In the matter of the Resource Management Act 1991
And
In the matter of the Proposed Marlborough Environment Plan

Decision of the MEP Hearing Panel

Date of Decision: 20 February 2020

Figure 2.6: Vehicle Crossing for Residential Use for One Rural User in the Rural Environment, Coastal Environment, Rural Living or Coastal Living Zone.

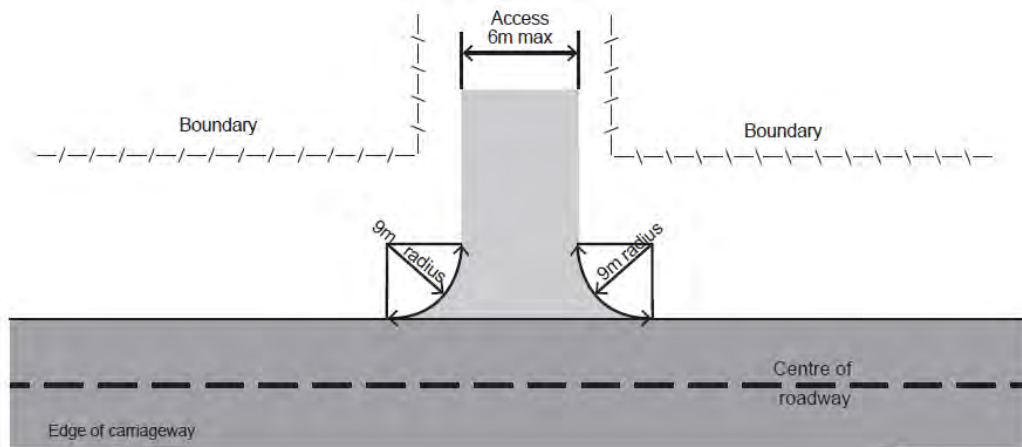
89. NZTA note that Figure 2.6 as presently drafted provides a 6.0m access. It said this should be a 9.0m radius.³⁶
90. NZTA note that Figure 2.7 should also be able to apply for some non-residential activities.

95. While considering the above matters, the Panel found it difficult to understand the detail in Figure 2.6 and Figure 2.7, particularly the relationship between the radius and the property boundary. In following this matter up with Marlborough Roads it was suggested that an alternative would be to set out a distance along the road frontage in addition to the width of the access.

96. To assist with understanding figures 2.6 and 2.7, an alteration to the diagrammatic presentation has been made to more clearly demonstrate the setbacks required.
97. The Panel confirmed the amendment of Figure 2.6's radius measurement to state 9.0m rather than the currently stipulated 6.0m.³⁸

98. Figure 2.6 is amended as follows:

Figure 2.7: Vehicle Crossing for Residential Use for 23- 6 Rural Users in the Rural Environment, Coastal Environment, Rural Living or Coastal Living Zone

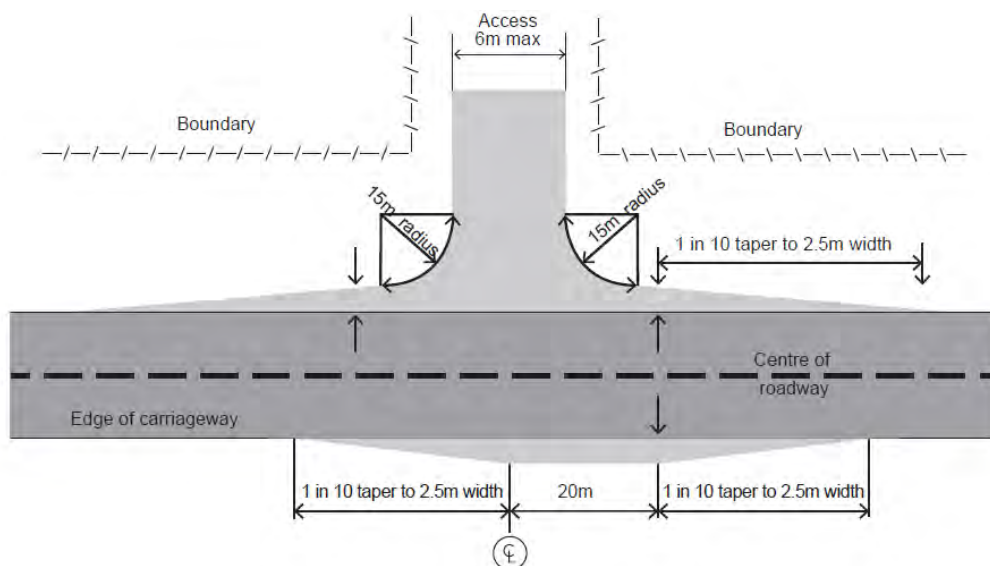
93. Figures 2.6 and 2.7 should apply to some non-residential activities by adding 'appropriate non-residential use' to the figures and renaming the term 'Rural' in the Figure headings so that they apply to any residential use only. There is also no clear direction or diagram for activities that are not residential. NZTA seek to add 'and agreed by the Road Controlling Authority' to the end of 2.32.4.3 acknowledging that activities other than residential must be constructed to a commercial standard. This is not accepted by the Panel because it provides discretion to a third party.

94. The removal of the word 'Rural' from the figure 2.6 and 2.7 headings is required so that there is greater certainty as to the activities that the standard applies to. The Panel was concerned that the term rural user was ambiguous.

99. Figure 2.7 is amended as follows:

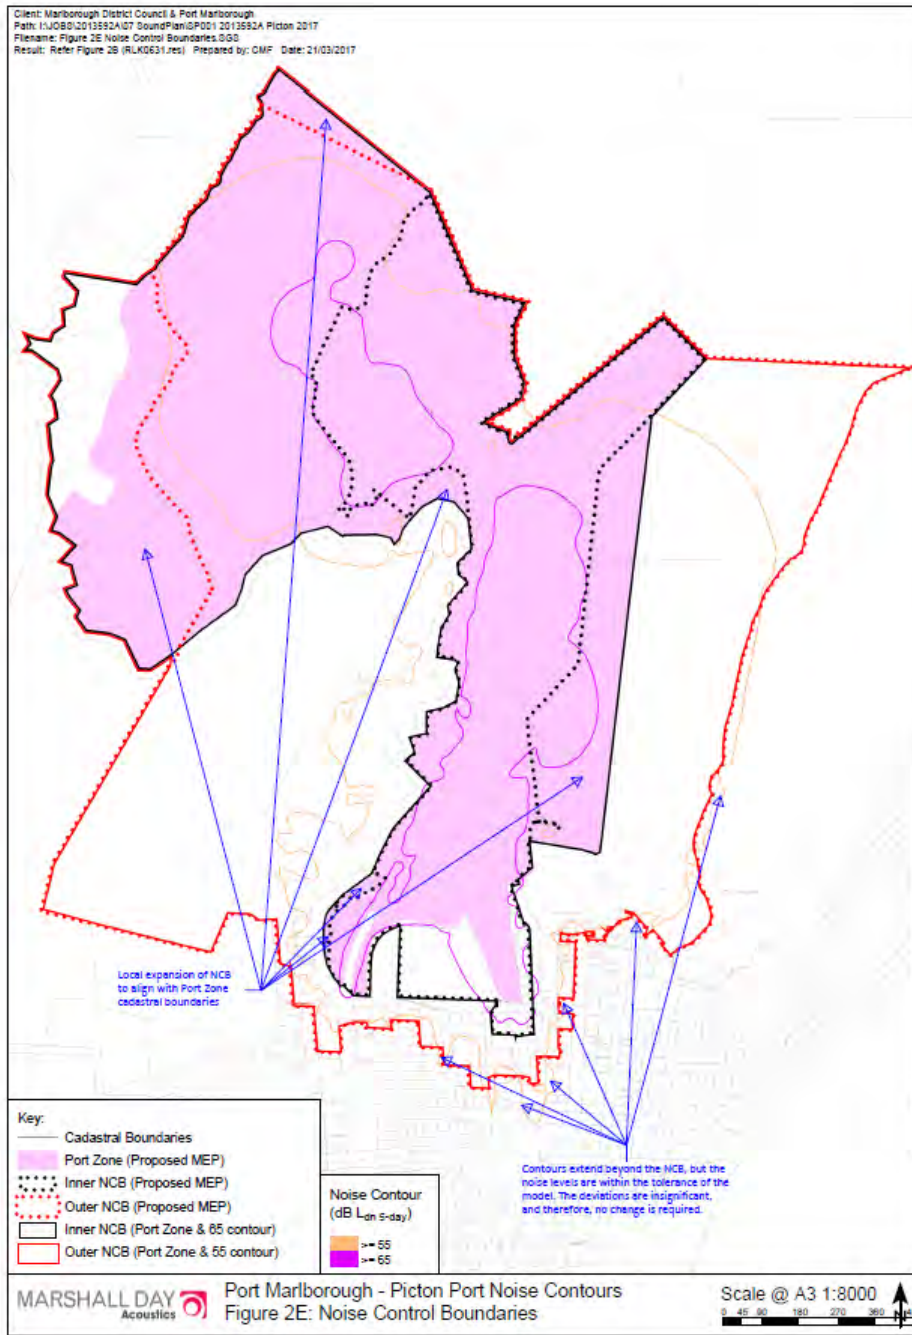
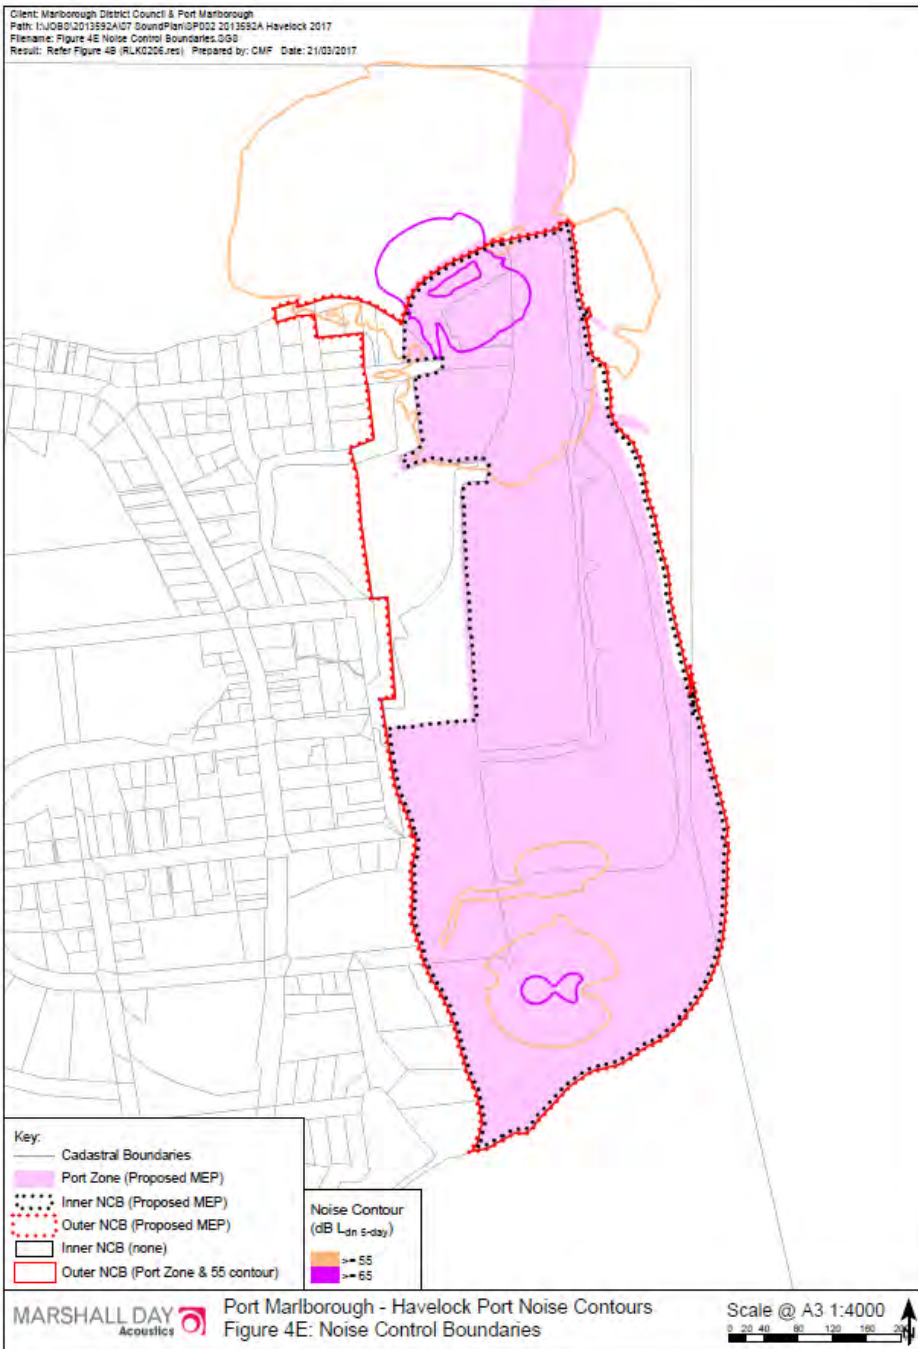
- *We recommend that NCBs be expanded to align with the outer extents of the Port Zone boundaries where the noise contours do not extend beyond. This as a practical simplification with no material change to the noise effects or applicable controls. With reference to Figure 2E, there are six locations in Picton and Shakespeare Bay where proposed NCB's are positioned within the proposed MEP Port Zone.*
- *The revised future contours extend beyond the proposed MEP Outer NCB in six locations in Picton. However, no changes to the NCBs are recommended in Picton because changes in predicted noise levels are within the tolerance of the model and not significant.*
- *The Havelock rules relate to the Outer NCB. Therefore, we understand that the Inner NCB serves no purpose and has been removed for simplicity (note if retained it would be unchanged).*

186. The Panel adopted the revised boundaries based on Marshall Day remodelling. This reflects both accurate and up-to-date information but also a degree of practicality where the noise control boundaries do not extend to the Port Zone boundary. As the purpose of the noise control boundary, and associated rules, is to manage adverse noise effects beyond the port, the Panel agrees that in this situation the noise control boundary should be located at the zone boundary.

187. The Picton port noise control boundaries are amended to reflect those shown on Figure 2E: Noise Control Boundaries, attached to the evidence of Port Marlborough and shown below.
188. The Havelock port noise control boundaries are amended to reflect those shown on Figure 4E: Noise Control Boundaries, attached to the evidence of Port Marlborough and shown below.
